**NOTICE OF A REGULAR
PLANNING COMMISSION MEETING
October 7, 2026, at 7:00 PM**

Agenda Item: PLAN26-0011 Site Plan Application - Minor Amendment Orchards Phase 7

The Orchards Phase 7: Building 53

THE ORCHARDS AT HOMESTEAD
PHASE 7 & 8 - BUILDING 59
VINYARD UTAH

SHEET TITLE:
EXTERIOR ELEVATIONS
DESIGN OPTION 2

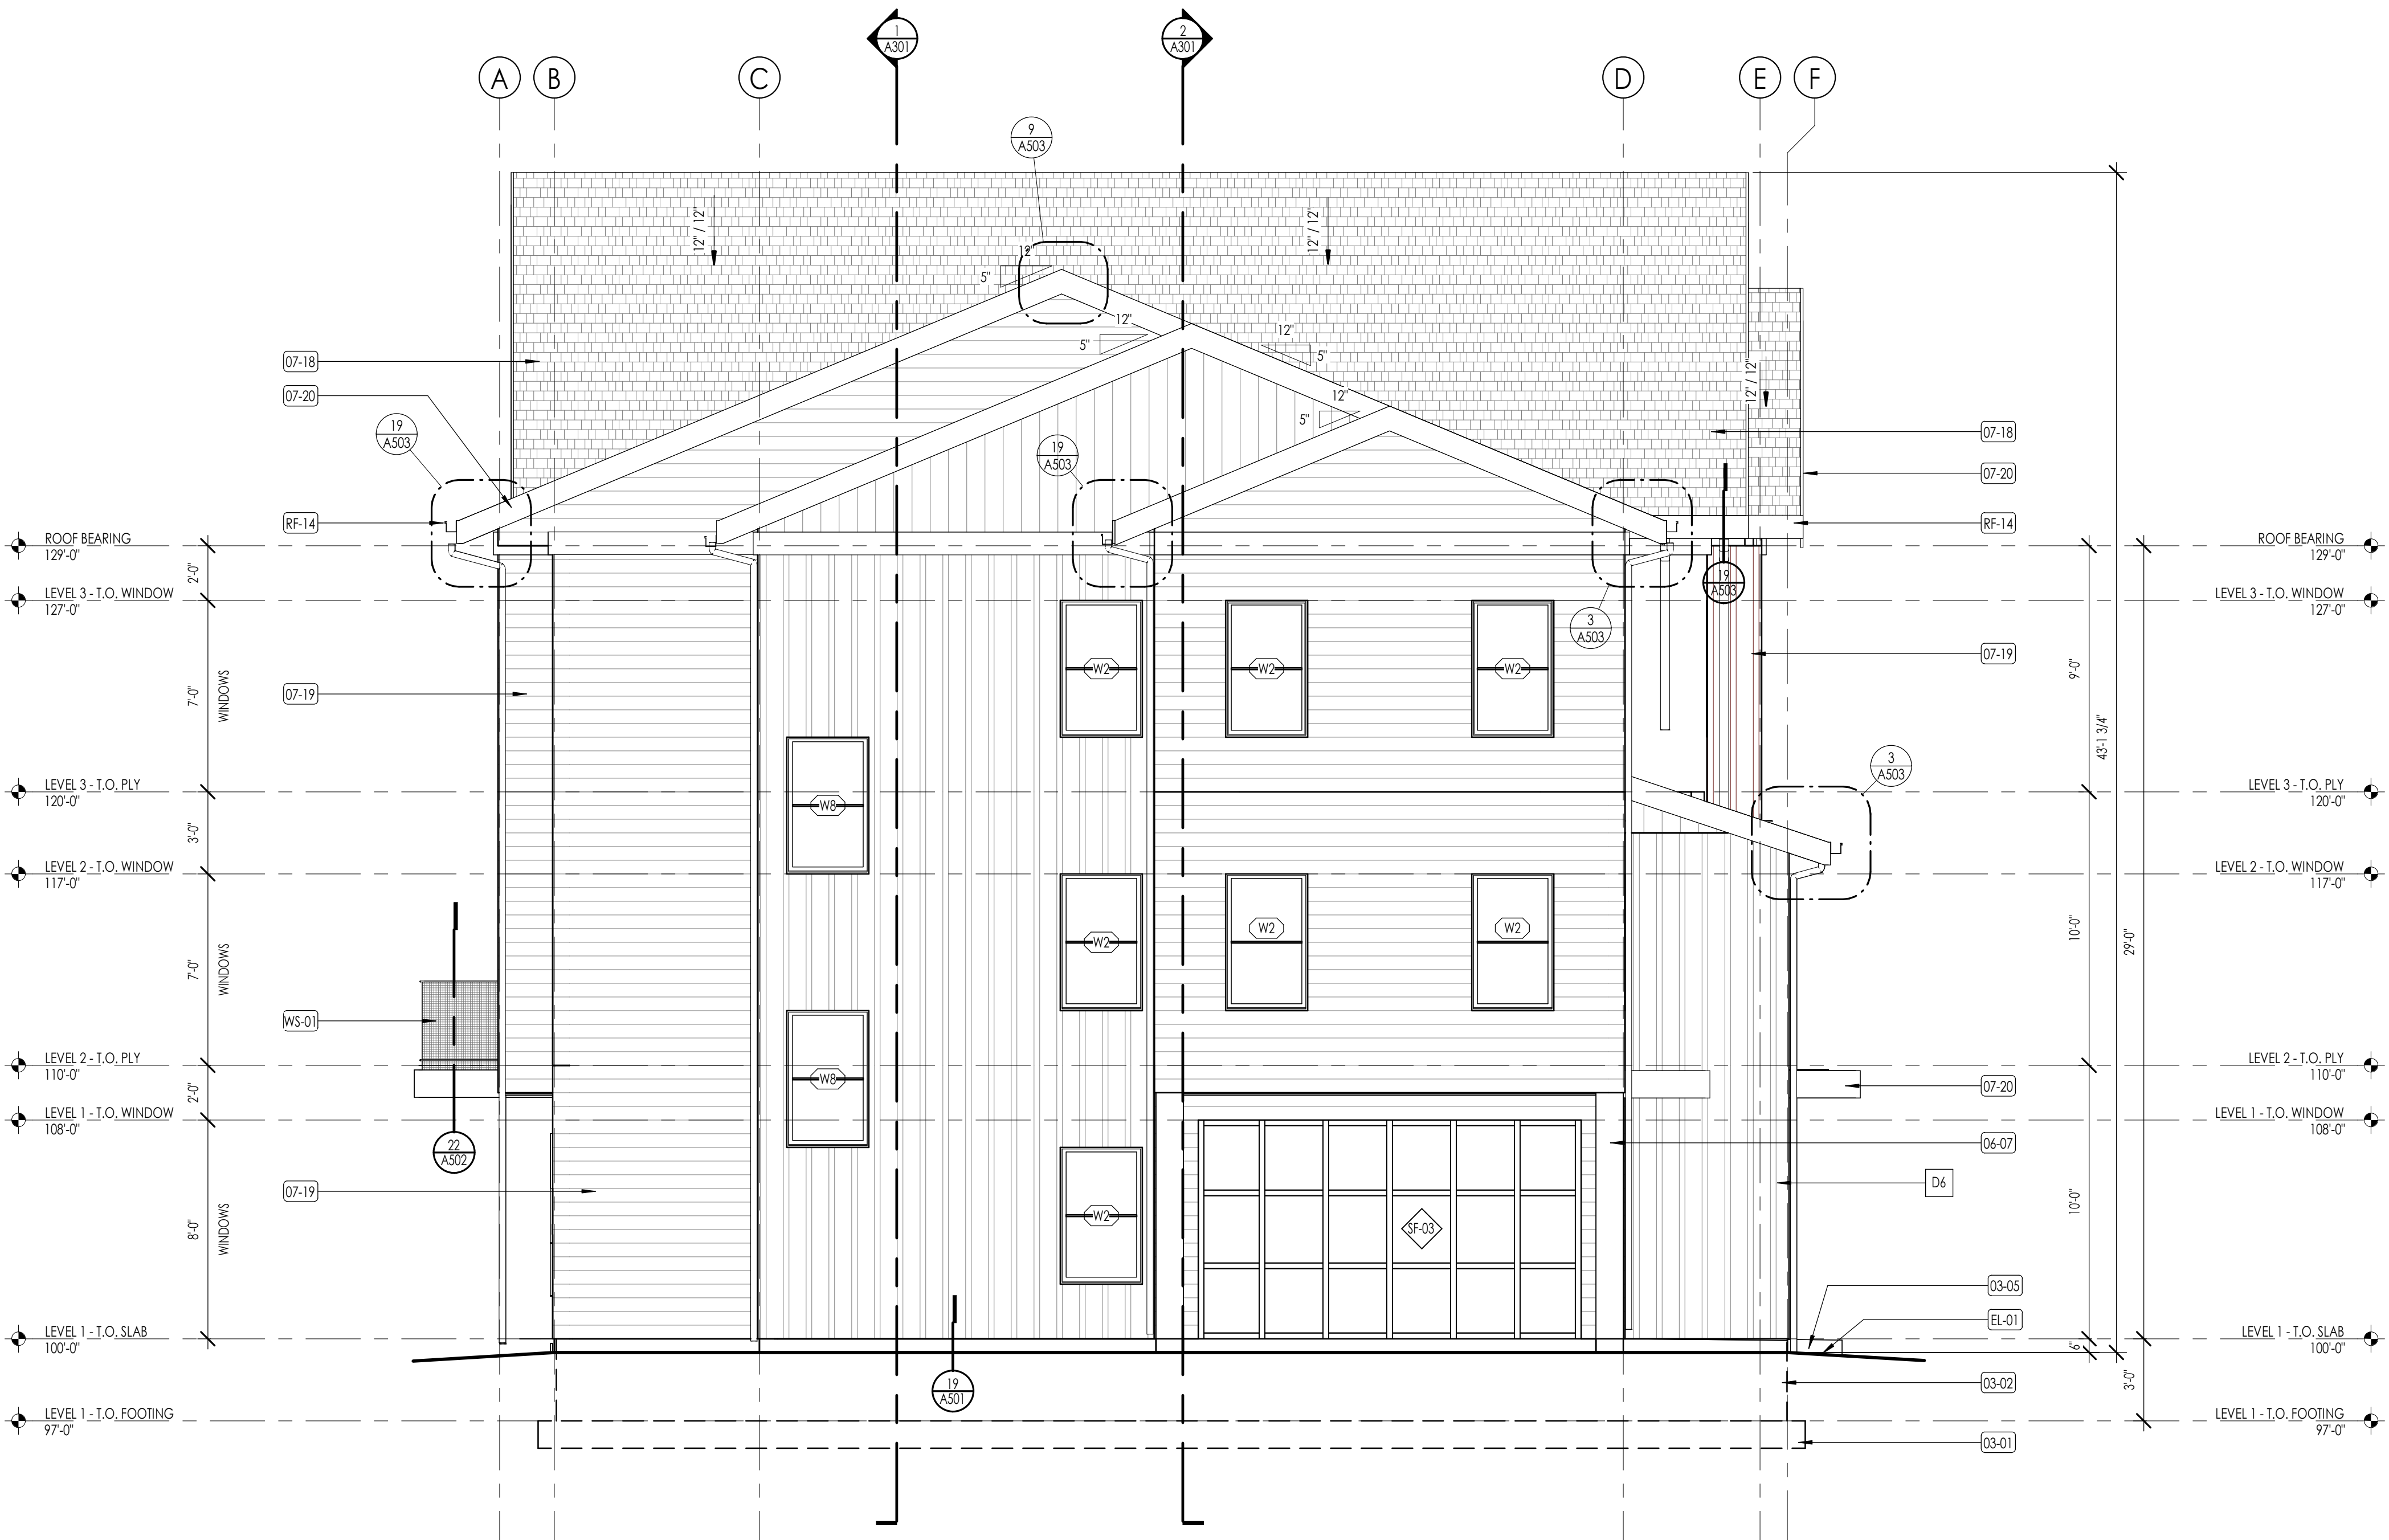
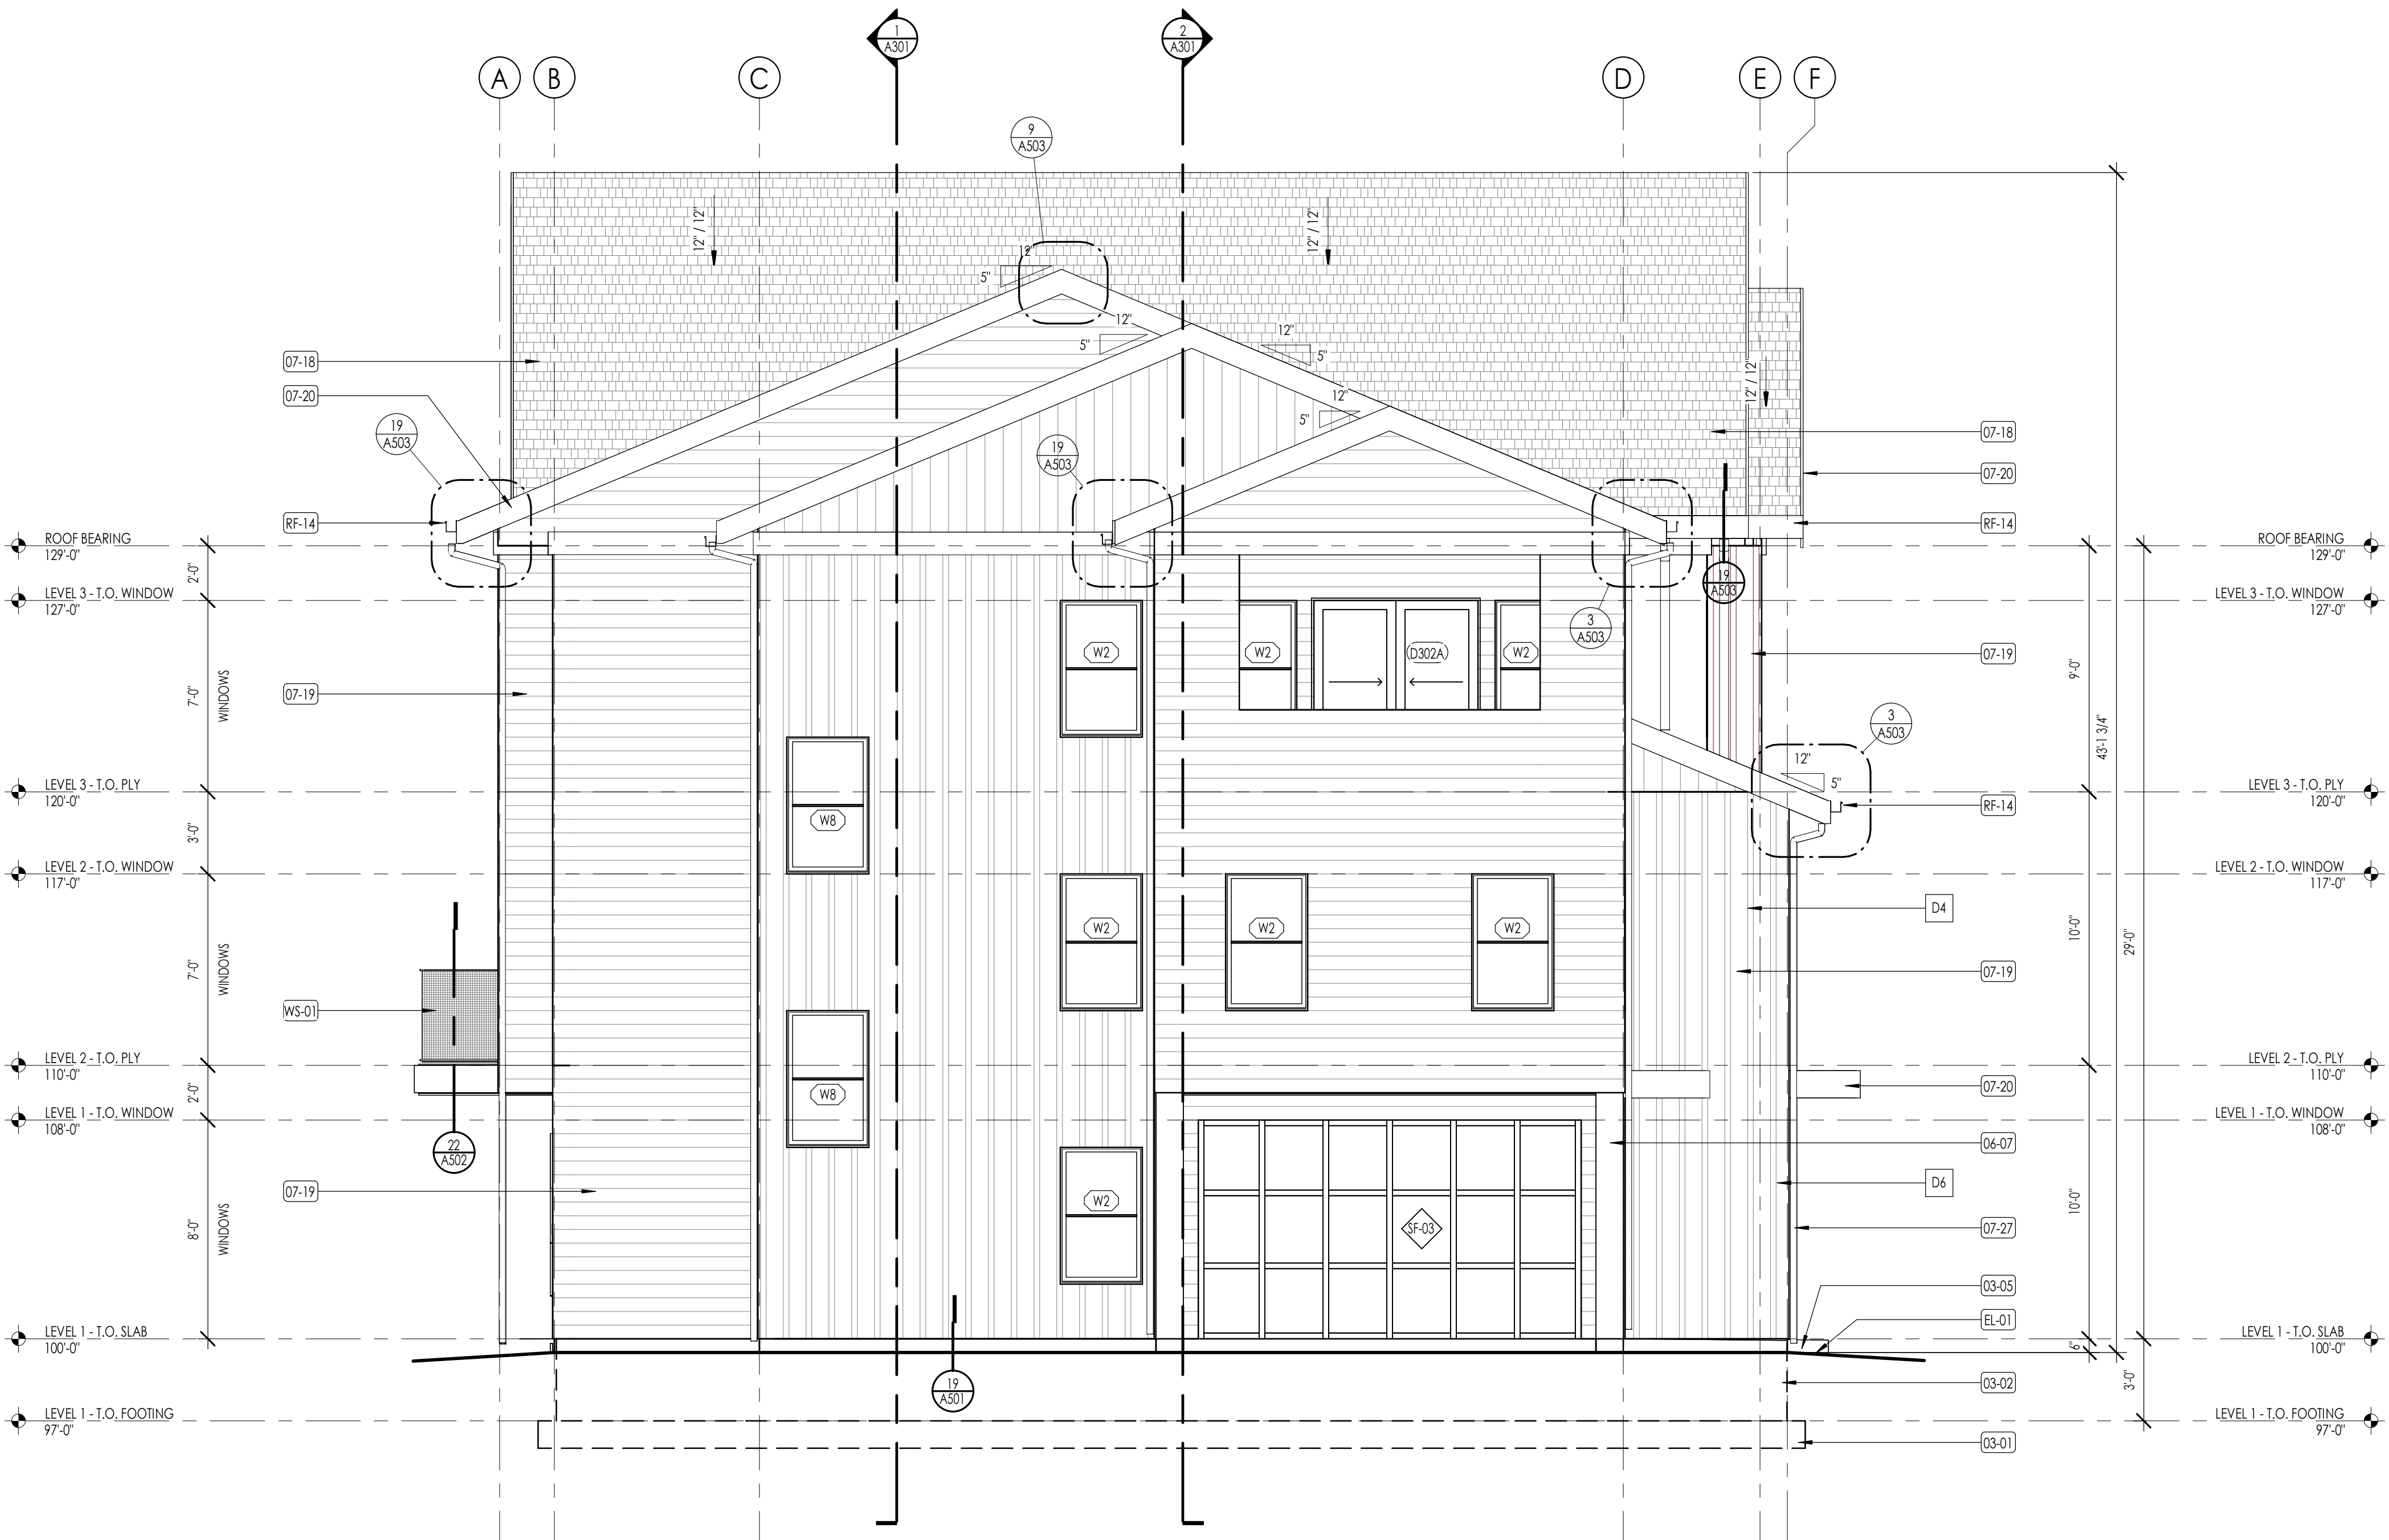
- The Two Units affected are the Unit K and Unit J only.
- The change was to infill the openings around the deck which has been converted into a bedroom. The room is now enclosed, with windows installed in the locations where the deck openings were previously located.
- The exterior siding and roof remain unchanged.
- For Unit Type D, the Level 2 deck has been revised to include a opening in the original brick wall with a railing, providing improved visibility and light to the interior while allowing for more positive deck drainage.
- The storefront color has been changed from dark bronze to white to maintain consistency with the other buildings throughout the development.

Section 5: Section 15.32.280 “Clear View Triangle On Corner Lots” of the Vineyard Zoning Code is amended as follows:

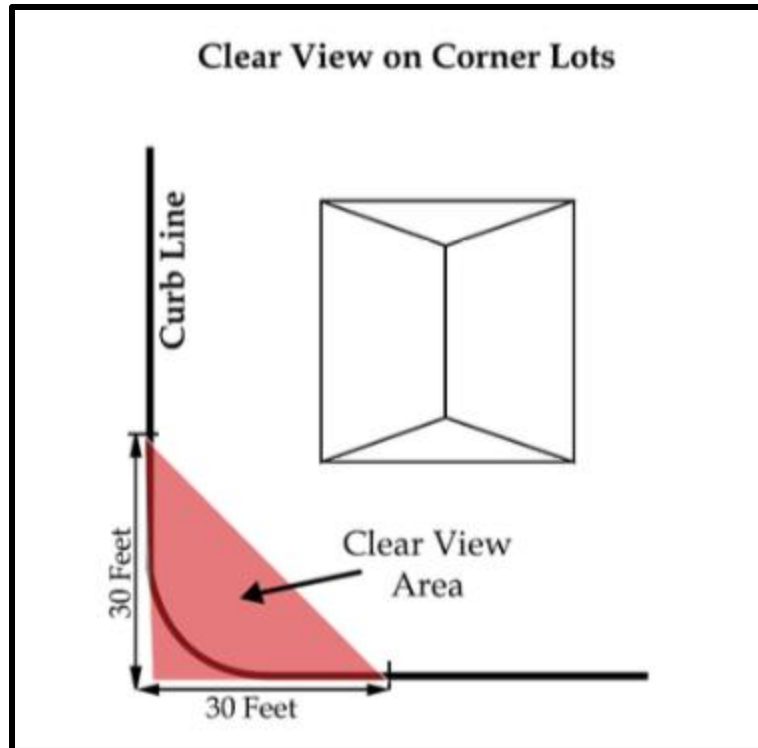
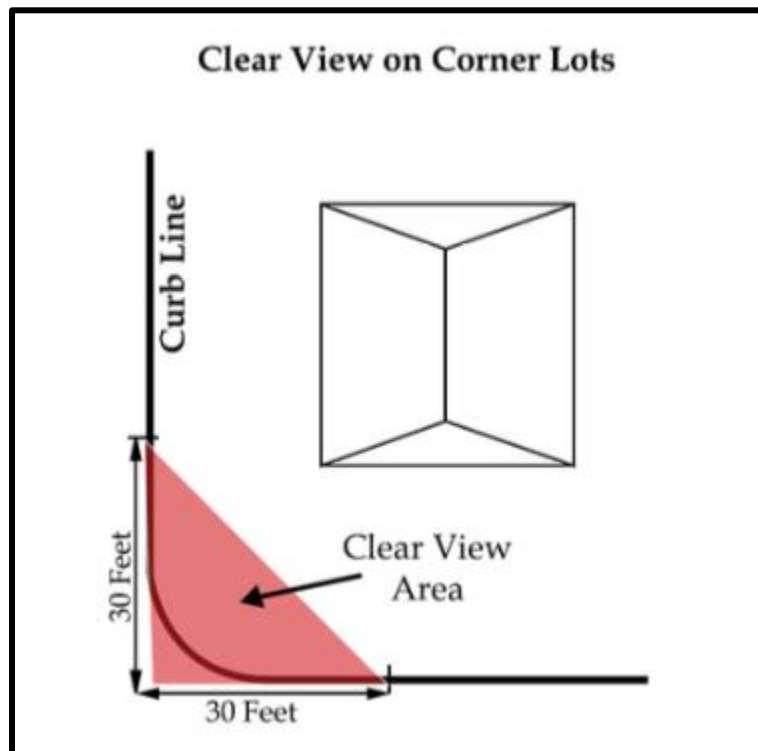
Where two local residential roads intersect within a planned subdivision, no view obstruction including a sight-obscuring fence, wall, sign, other similar structures, and landscaping which exceeds two (2) feet in height shall be placed on any corner lot within a triangular area formed by a diagonal line connecting lines located at the curb line thirty (30) feet from the projected intersection of such curb lines. Where no curb exists, the clear view area shall include that portion of the corner lot lying within a triangular area formed by a diagonal line connecting lines located at the property line twenty (20) feet from the intersection of said property line. Use the Vineyard City Access Management Manual to design sight triangle dimensions for all other intersections.

In all Zoning Districts Where two local residential roads intersect within a planned subdivision, no view obstruction including a sight-obscuring fence, wall, sign, other similar structures, and landscaping which exceeds two (2) feet in height shall be placed on any corner lot within a triangular area formed by a diagonal line connecting lines located at the curb line thirty (30) feet from the projected intersection of such curb lines. Where no curb exists, the clear view area shall include that portion of the corner lot lying within a triangular area formed by a diagonal line connecting lines located at the property line twenty (20) feet from the intersection of said property line. Use the Vineyard City Access Management Manual to design sight triangle dimensions for all other intersections.

Section 6: Section 1.08.040 (S) "Intersection Design" of the Construction and Design Specifications is amended as follows:

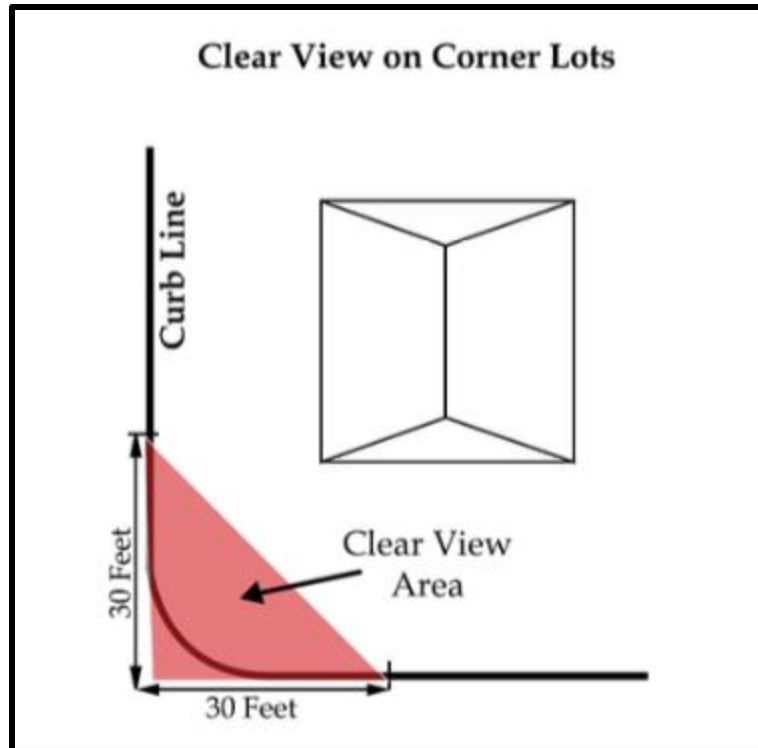
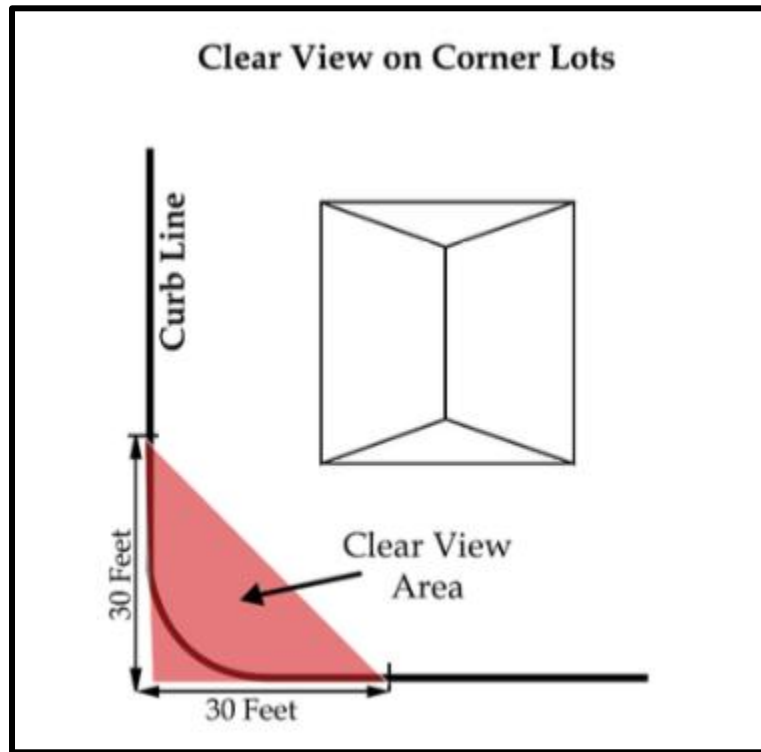
6. Sight Distance Triangle. Where two local residential roads intersect within a planned subdivision, no view obstruction including a sight-obscuring fence, wall, sign, other similar structures, and landscaping which exceeds two (2) feet in height shall be placed on any corner lot within a triangular area formed by a diagonal line connecting lines located at the curb line thirty (30) feet from the projected intersection of such curb lines. Where no curb exists, the clear view area shall include that portion of the corner lot lying within a triangular area formed by a diagonal line connecting lines located at the property line twenty (20) feet from the intersection of said property line. Use the Vineyard City Access Management Manual to design sight triangle dimensions for all other intersections.

~~other intersections. A clear line of sight must be provided at all intersections, see Vineyard City Access Management Manual. The “Sight Distance Triangle” must be calculated using the stopping “Sight Distance” of the road being intersected. The stopping “Sight Distance” is 200 feet for a Local street, 300 feet for a Collector and 425 feet for Arterial. The figure below illustrates the required “Sight Distance Triangle” based on the “Sight Distance”.~~
